BMP NUMBER: **PC153**

Property Description: Blue Heron Course Holes 5-13

James City County
Environmental Division
Single Family Plan Submittal - Miscellaneous

Lot 149, Ford's Colony, Section 6 (108 Berrow)

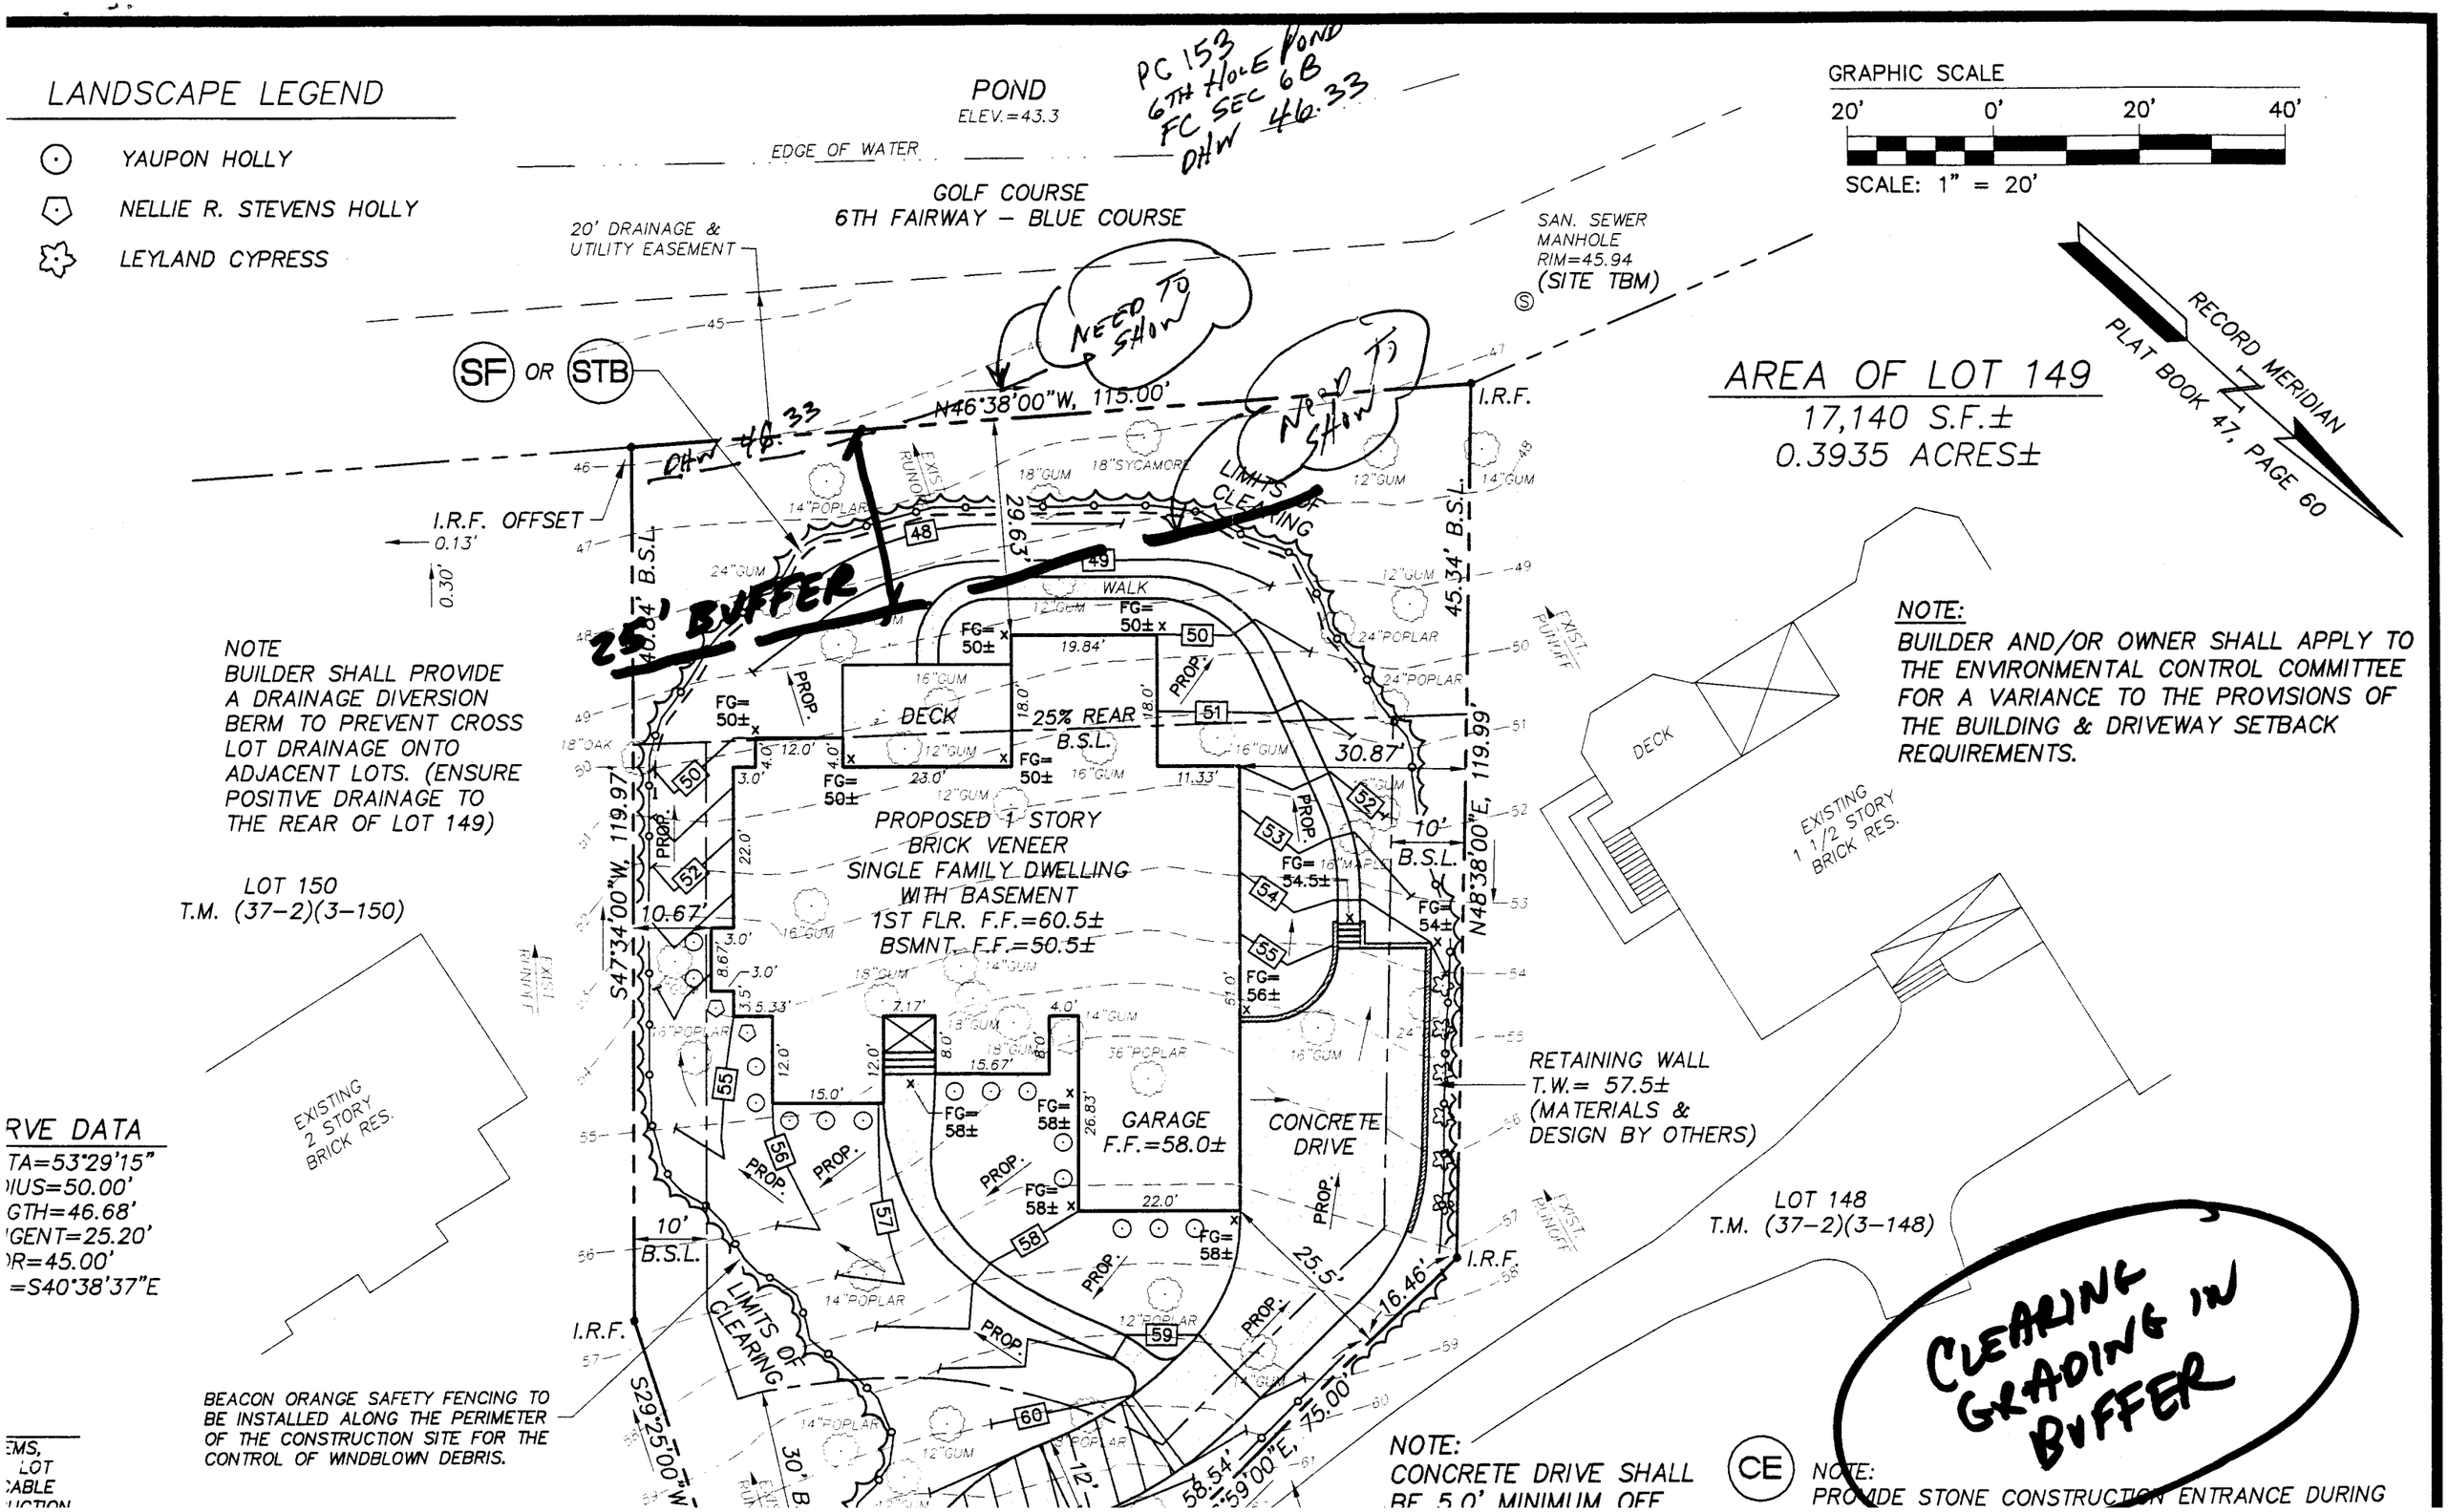
It appears that clearing and grading is proposed within the 25 ft. pond setback/buffer as required per page 38 of the James City County BMP manual. The pond buffer extends 25 feet outward from the maximum water surface elevation of the pond. Based on available information, it appears the 100-year design high water surface elevation for the adjacent wet pond facility (County BMP ID Code: PC 153, 6th Hole Pond, Fords Colony Section 6) is at Elevation 46.33.

Delineate design high water elevation and the corresponding 25-ft. pond setback/buffer situated on Lot 149. Efforts should be made to preserve existing trees and vegetation in the buffer during construction and to manage the buffer as meadow or forested area. Reconfigure the limits of clearing and grading as shown on the plan to avoid disturbance of the buffer; or alternatively, submit a written request for waiver to the Environmental Division with information to support the waiver request including the intended plan for stabilization or landscaping to restore disturbed buffer area back to meadow or forest condition using native trees, shrubs or ground cover to the greatest extent possible.

Variance request dated March 28th 2002 to the JCC BMP Manual pond buffer and setback requirements was reviewed and found to be acceptable. Efforts should be made to preserve existing trees and vegetation in the buffer during construction and to landscape the buffer (in graded slope areas) to resemble meadow or forest area with trees, shrubs and native ground cover to the greatest extent possible.
